WADSWORTH PARISH COUNCIL RESPONSE TO CALDERDALE ENERGY PARK'S STATUTORY CONSULTATION

(PINS Reference: EN0110023, April 2026)

7 June 2026

Figure 10.4.8

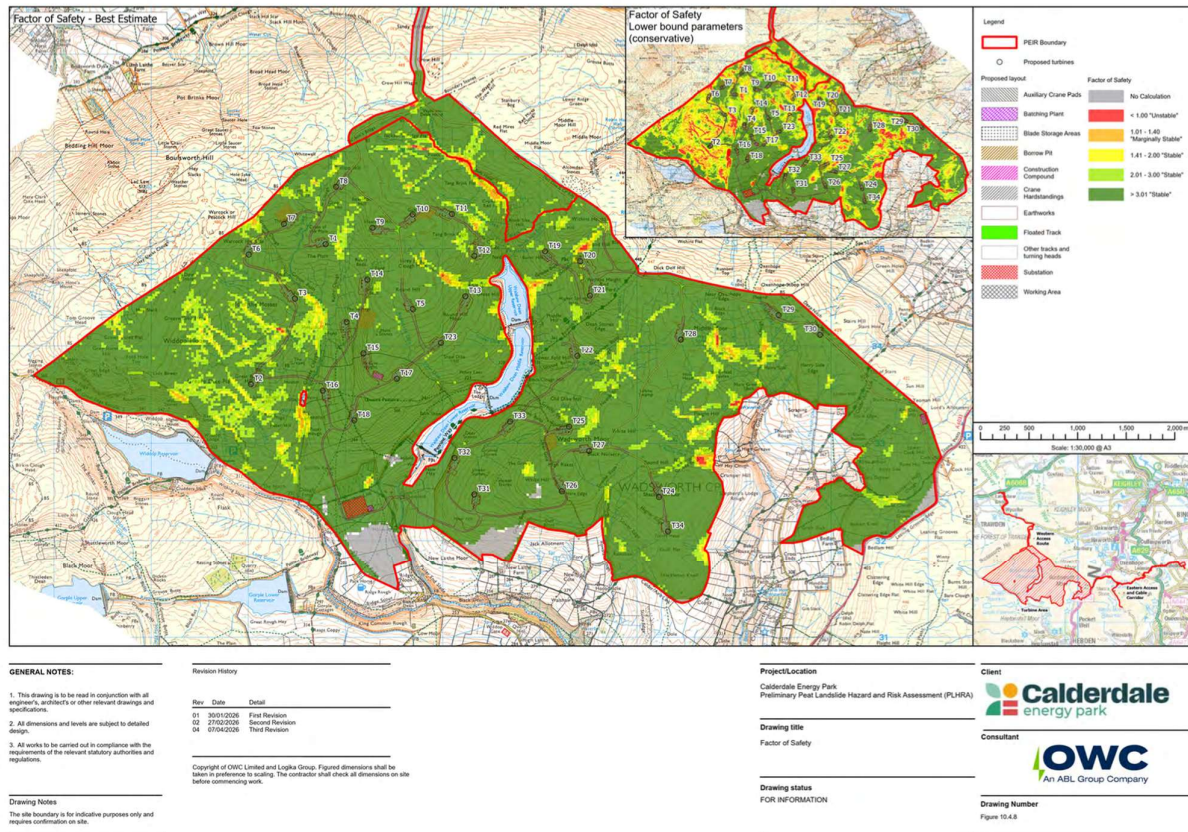
They also appear to be selective about which parameters they use. In their baseline Factor of Safety test (drained analysis) they used parameters on the high side to produce the map (Figure 10.4.8, reproduced below) that shows all the locations for the proposed infrastructure in the Turbine Area is safe (green).

Figure 10.4.8 also includes a cursory look at what they call "lower bound parameters (conservative)" with the results presented in a smaller inset window. Quite a bit more red, here, i.e. a Factor of Safety <1.0, which is a fail.

They are downplaying the lower parameters and declaring them conservative without any basis for doing so, as they haven't tested a single sample. It's only the higher assumed parameters that is giving them the sea of green on Figure 10.4.8 which shows the results of their baseline analysis. The sea of green means a factor of safety of more than 2.0 or even 3.0, in other words the restoring forces exceed the disturbing forces by 2 to 3 times. In the top right and much smaller are the results for the lower bound parameters, so cohesion = 2 kPa and friction 20 degrees. Quite a bit more red, here, i.e. a factor of safety <1.0 which is a fail.

Figure 10.4.9

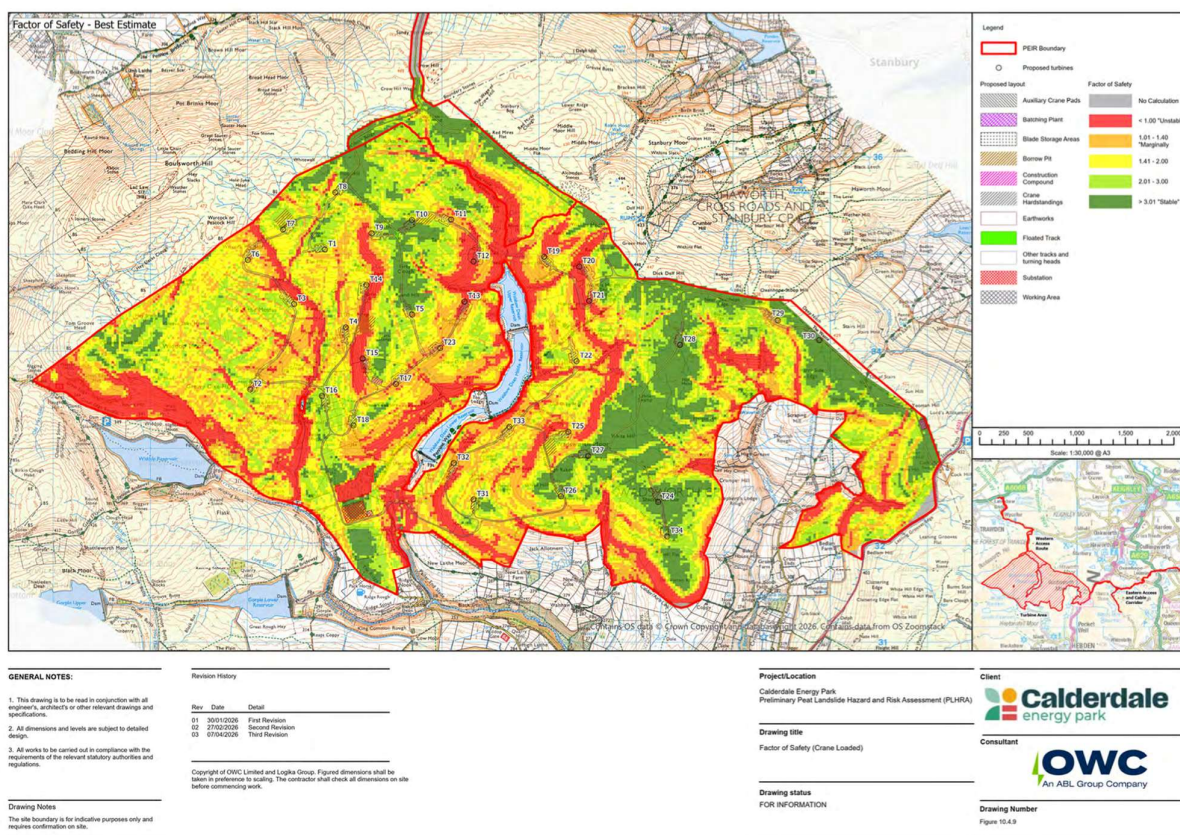
Undrained strengths are applicable for short term loadings on fine grained soils, but peat is a free draining soil, and it is unlikely that it can retain pore water pressures when loaded, as simply the water drains away like squeezing water out of a sponge, particularly over the duration that the axle will be loading the ground whilst standing idle. This radically alters the behaviour of a soil and arguably they should be using the same drained approach as they did for the baseline study, which I would expect would return lower factors of safety. As it is, the results of the Crane Loadings Factor of Safety analysis are mapped in figure

10.4.9. They are actually quite alarming. Look at the amount of red here, factors of

safety less than 1.0 "Unstable". It is likely they would be even worse had they used the drained parameters approach.

This is about the quite alarming results at Figure 10.4.9 of their analysis for the crane loadings.

We have prepared our own calculations summarised below by reviewing 10.4.9 to pick out the turbines that are close to or on red areas, column E, this defines if there is an issue. We have then looked at slope angle from Figure 10.4.2, column D. We have then determined which Turbine needs further attention at Column F and assigned a
